Groundwater Transfer Review Summary Form

Transfer/PA # T- 13658

Application: T-13658

Applicant Name: Mike Becker

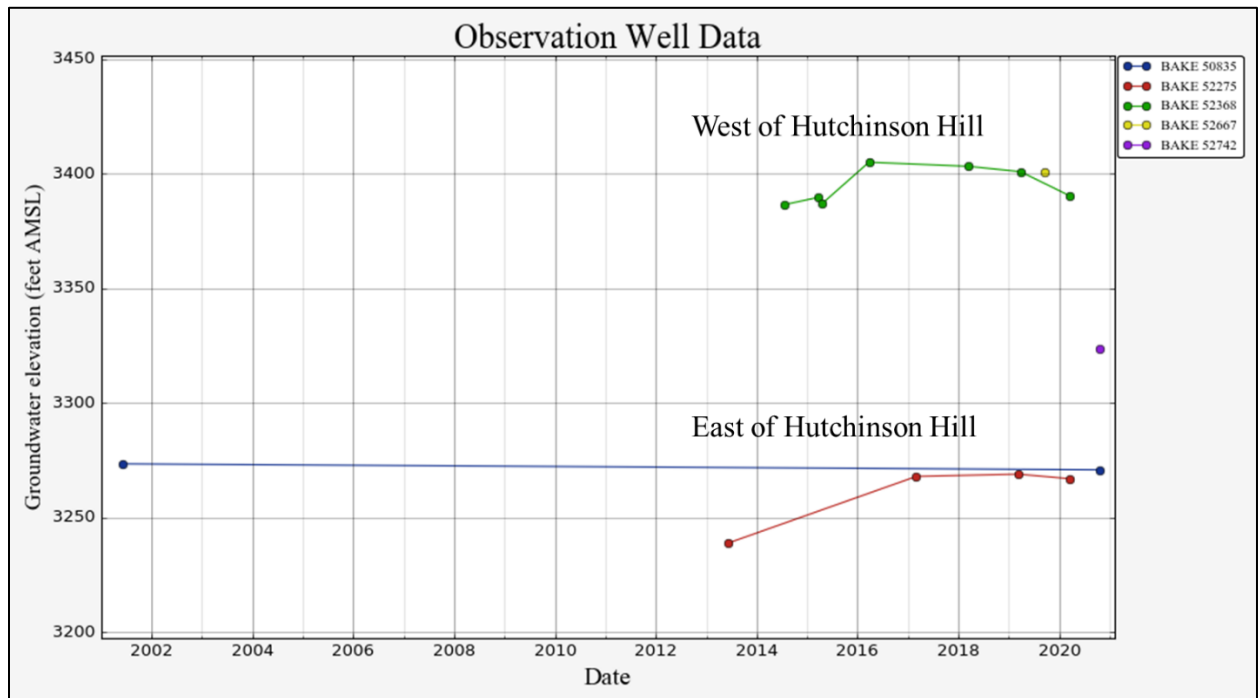
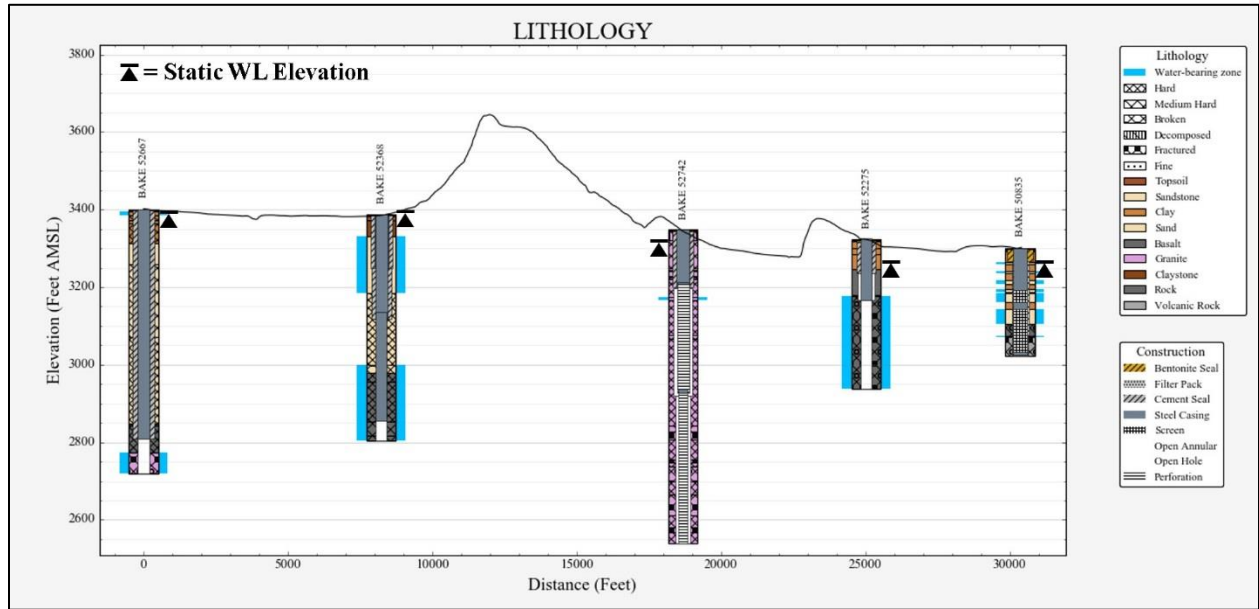
Water level data indicate groundwater elevations are much higher on the west side of Hutchinson Hill, with no apparent relation to which bedrock lithology is developed. Consequently, there do not appear to be separate “bedrock” aquifers, but instead aquifers distinguished by geography.
